UNITED STATES DEPARTMENT OF COMMERCE
Patent and Trademark Office

APPLICATION NO.	FILING DATE	FIRST NAMED INVENTOR	ATTORNEY DOCKET NO.
09/473,315	12/28/99	MOSLEY	L 884.209US1

Office Action Summary

DETAILED ACTION

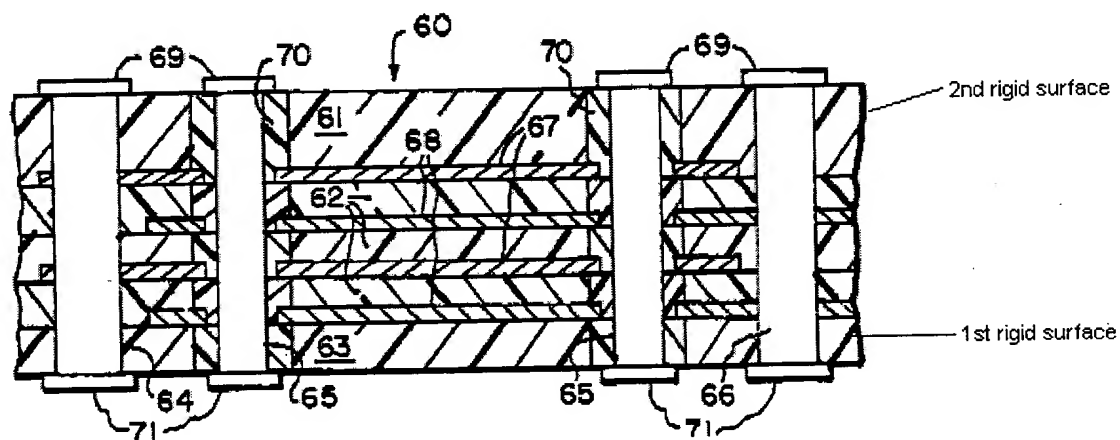
Regarding claim 9, Farooq et al. disclose in fig. 3 A, a multilayer capacitor having a pair of substantially rigid outer surfaces (see below), and a number of pads (69) located on two of the number of outer surfaces; wherein two of the number of pads are capable of being coupled to a substrate using a solder bump.

Regarding claim 10, the multilayer capacitor includes a number of parallel

conductive layers and the number of pads are coupled to the number of parallel conductive layers through vias.

FIG. 3B

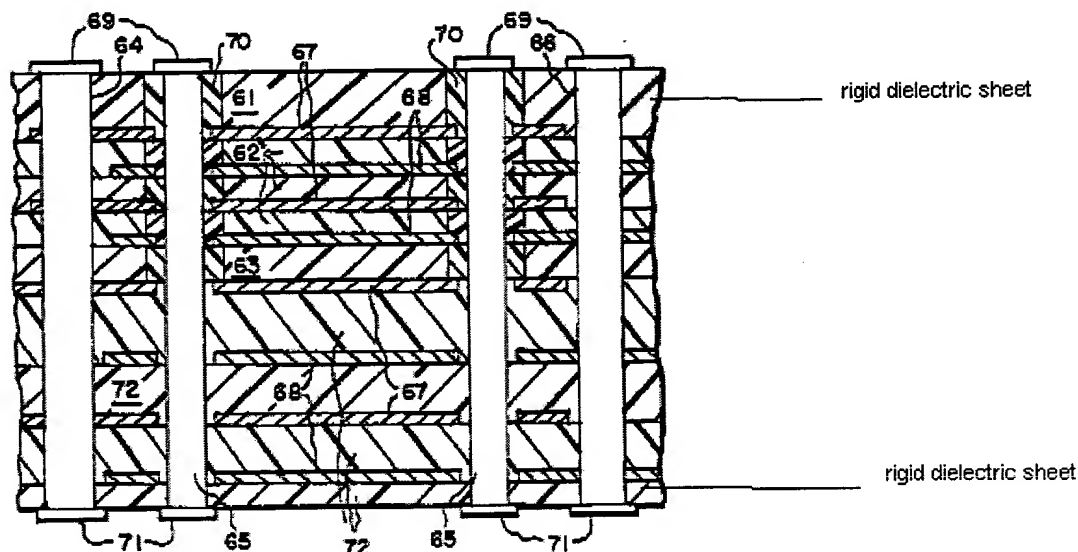
Regarding claim 6, Farooq et al. disclose (in fig. 3c) a plurality of first conductive layers (67), each of the plurality of first conductive layers formed on a first dielectric sheet (72); a plurality of second conductive layers, each of the plurality of second conductive layers formed on a second dielectric sheet (72), and the plurality of second conductive layers interlaced with the plurality of first conductive layers; a pair of dielectric sheets (see below) having a thickness, for providing a pair of substantially rigid outer surfaces for the plurality of second conductive layers interlaced with the plurality of first conductive layers, each of the pair of substantially rigid outer surfaces having a plurality of connection sites operable for coupling the capacitor to a substrate using a controlled collapse chop connection (C4); and a plurality of vias (64, 66) coupling the plurality of first conductive layers and the plurality of second plurality of second conductive layers to at least two of the plurality of connection sites.

Farooq et al. do not disclose the thickness of the pair of dielectric sheets having a thickness of slightly greater than 7 microns. It would have been an obvious matter of design choice to form the pair of dielectric sheets having a thickness of slightly greater than 7 microns, since such a modification would have involved a mere change in the size of a component. A change in size is generally recognized as being within the level of ordinary skill in the art. *In re. Rose*, 105 USPQ 237 (CCPA 1955).

FIG. 1

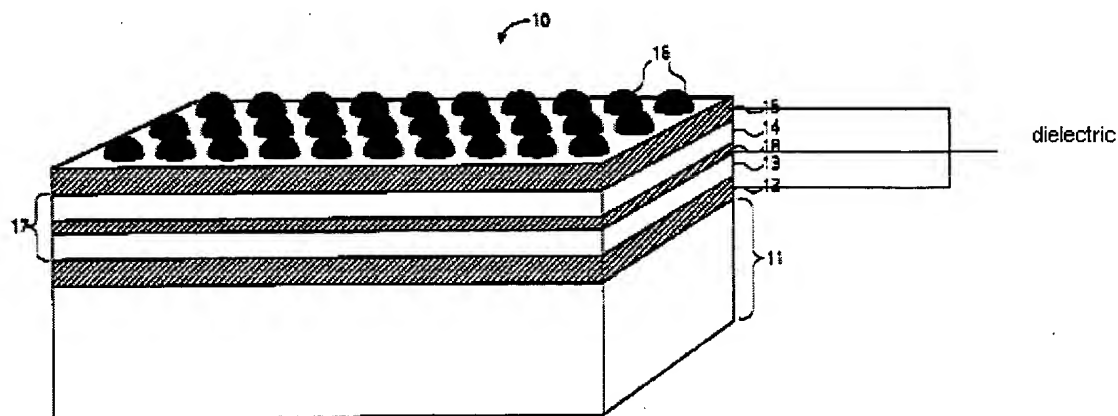
-The argument (pg. 4 first paragraph), "that reference number "12" is not described in Harrell et al., so conductive layer 13 is not embedded in a dielectric. Thus, only conductive layer 14 is embedded in a dielectric, and therefore Harrell et al. does not disclose "a plurality of conductive layers embedded in a dielectric"" is not persuasive. Element 12 in fig. 1 is a dielectric (as noted by the cross-hatching). See MPEP 608.02. Therefore, Harrell et al. does anticipate claim 1.
